TECHNICAL SERVICE BULLETIN

TECHNICAL SERVICE BULLETIN: 53-2073
SERVICE CAMPAIGN: 001302

TECHNICAL SERVICE BULLETIN 53-2073 REMEDY INSTRUCTIONS

FIGURE 1

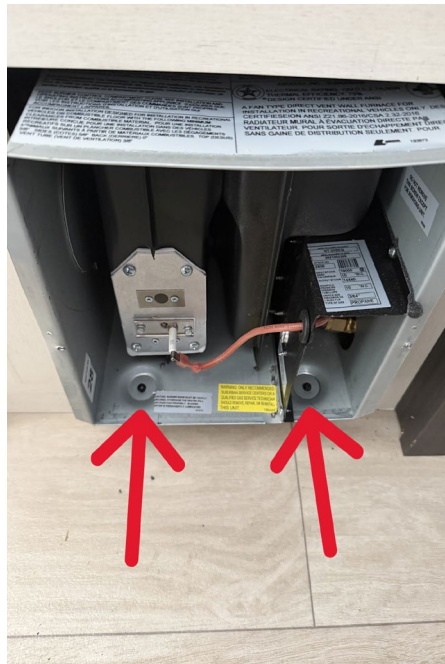
1. REMOVE SCREWS FROM FURNACE FLUE ON THE EXTERIOR OF THE UNIT AND LOOSEN SEAL
2. REMOVE THE 2 SCREWS FROM THE FRONT OF THE FURNACE GRILL ON THE INTERIOR OF THE UNIT (SEE FIGURE 1)

FIGURE 2

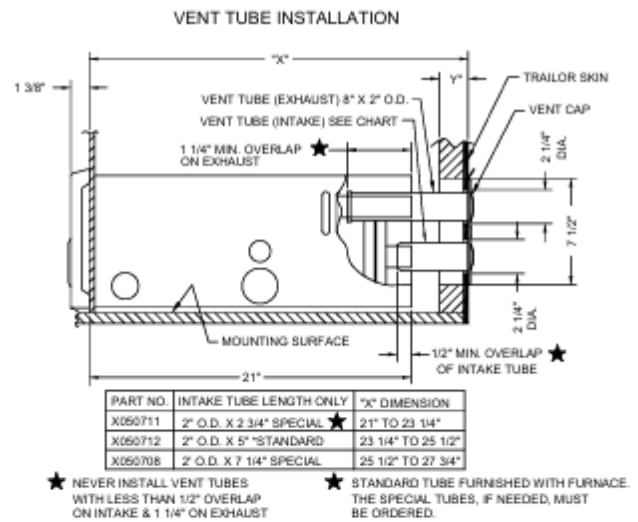
3. REMOVE THE 2 SCREWS THAT SECURE THE FURNACE TO THE CLEAT ON THE FACEFRAME (SEE FIGURE 2)
4. AFTER SCREWS ARE REMOVED PUSH THE FURNACE BACK INTO THE OPENING UNTIL THERE IS 1 3/8" CLEARANCE FROM THE FACE OF THE CABINET (SEE FIGURE 3 FOR INSTALL INSTRUCTIONS)

5. WHEN 1 3/8" CLEARANCE FROM THE FACE OF THE CABINET IS ACHIEVED, SECURE THE FURNACE IN PLACE USING THE 2 SCREW HOLES ON THE BOTTOM OF THE FURNACE (REFER BACK TO FIGURE 2)

FIGURE 3

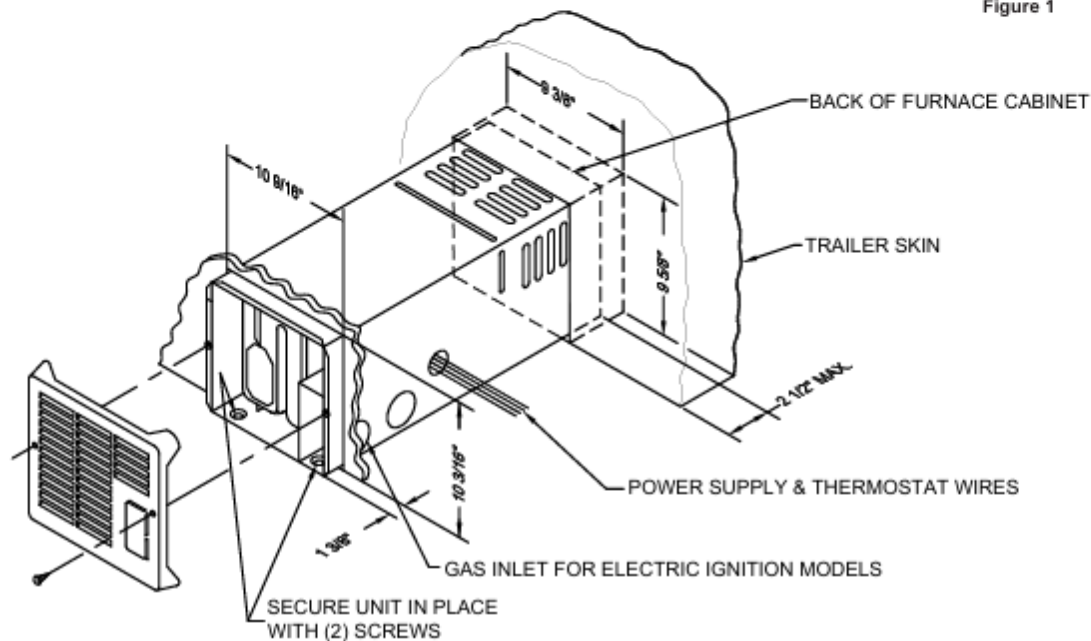
6. SCREW FURNACE GRILL BACK ON WITH 2 SCREWS
7. ON THE EXTERIOR OF THE UNIT REPLACE THE INTAKE TUBE WITH PROVIDED 5" INTAKE TUBE (SEE FIGURE 3 FOR PROPER OVERLAPS)

- a. NOTE THIS WAS A 7" INTAKE TUBE THAT NEEDS REPLACED WITH A 5" INTAKE TUBE
8. ENSURE THAT EXHAUST FLUE IS STILL PROPERLY LINED UP AND OVERLAPPING PROPERLY
